KMBC: Grace Park, Surface Water Drainage - Technical Note

DATE:	19 June 2026	CONFIDENTIALITY:	Confidential
SUBJECT:	Drainage Strategy Addendum		
PROJECT:	UK0029006.8015 KMBC Grace Park LUF	AUTHOR:	Harry Richardson
CHECKED:	Gareth Hardwick	APPROVED:	Andrew Leadbetter

This technical note has been produced to summarise the amendments made to the drainage strategy detailed in WSP document 70119719_WSP_HDG_RP_0002, outlining the changes made and confirming how these still adhere to the overall aims of the drainage strategy.

0029006.8015-WSP-HDG-GR-DP-0002

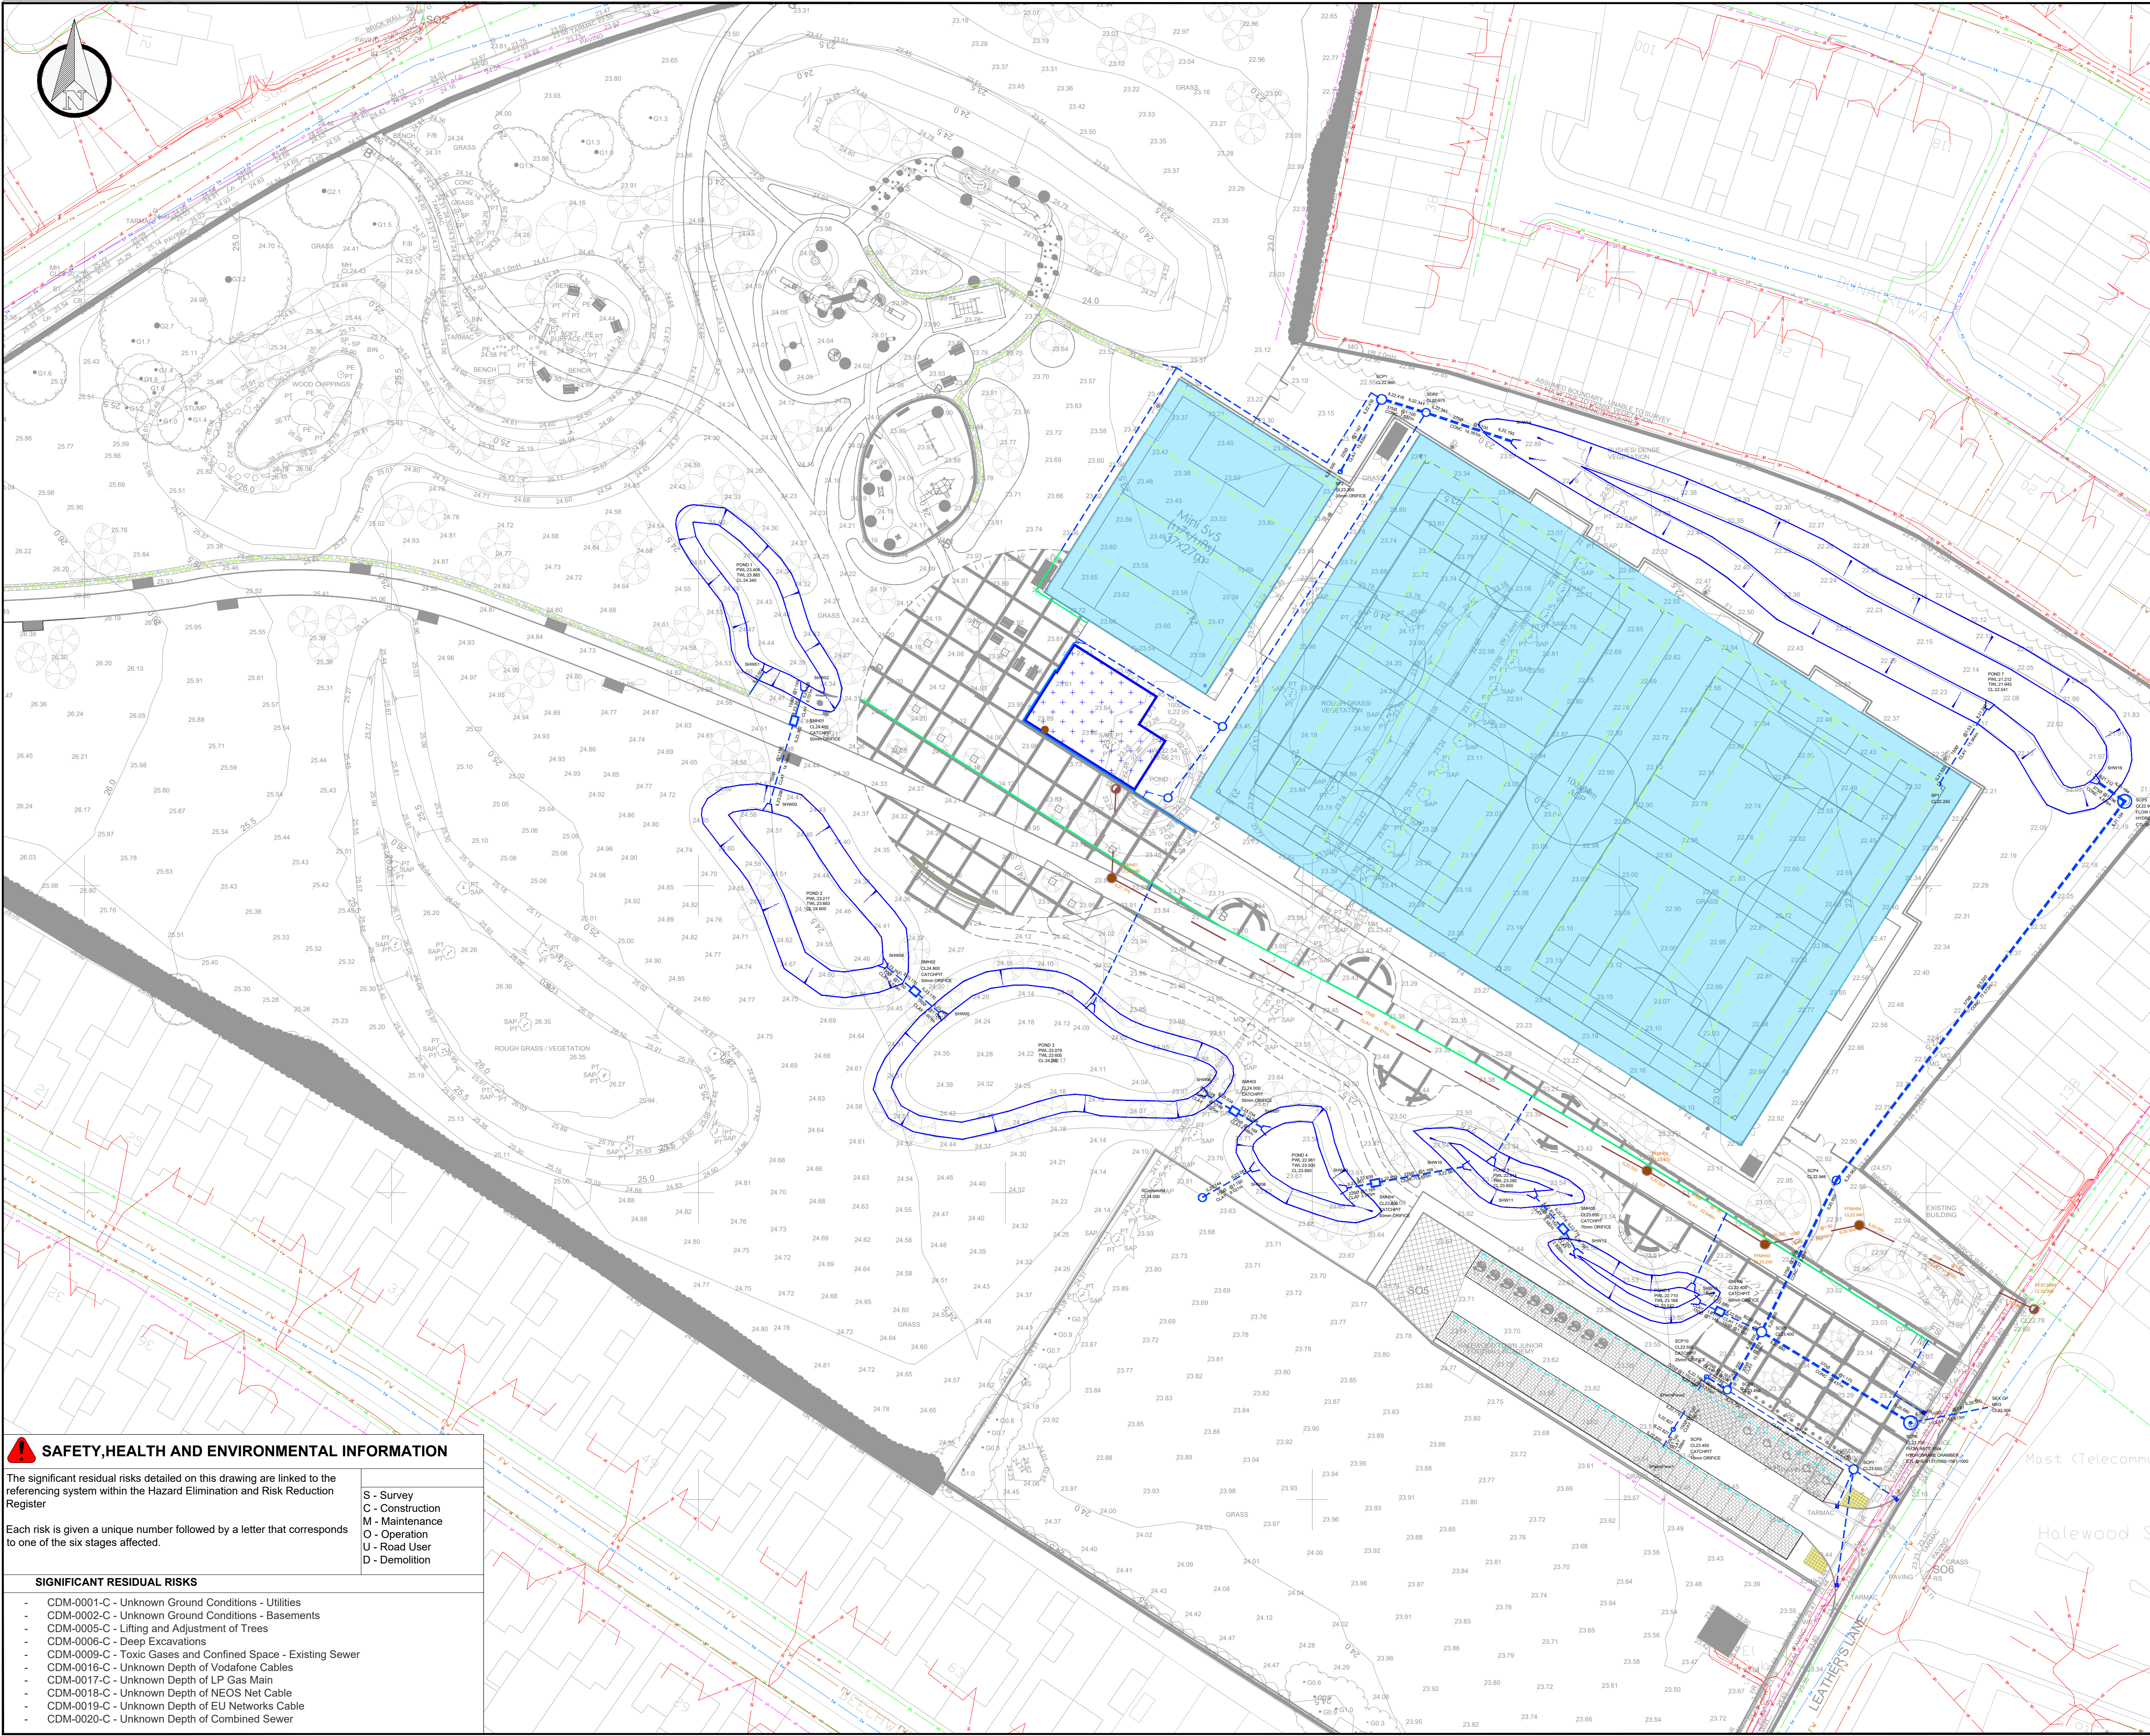
REPLACE CAR PARK GEOCELLULAR ATTENUATION CRATES WITH ADDITIONAL STORAGE IN POROUS ASPHALT LAYER

- Replacing the geocellular attenuation crates with a porous asphalt surface within the car park removes the need for deep excavations during construction and demolition, as the storage is kept at a shallow depth.
- The maintenance of the porous asphalt is all completed on the surface, with no regular maintenance requiring excavation or entry into a sub-surface system.
- The known perched groundwater within the site would require the geocellular attenuation crates to be designs to counteract hydrostatic uplift pressures, which can lead to increased construction costs. The shallower construction of the porous asphalt reduces this.

REMOVE GEOCELLULAR TANK UNDER BASIN

- With an increase in the flow restrictions across the 6no. basins in tandem, the collected rainfall will be retained for longer throughout the basins. The increase in upstream storage usage, in tandem with the porous asphalt storage capacity, allows for the removal of the geocellular attenuation crates located underneath the basin.
- Removal of the crates reduces the construction risks, alongside any potential maintenance or repair requirements throughout usage. If remedial works were required to the geocellular attenuation crates, there could be negative ecological impacts associated with the works, as the basin above would likely be damaged.

ATTENUATION TANKS AND OIL SEPARATORS REMOVED FOR POROUS ASPHALT CONSTRUCTION
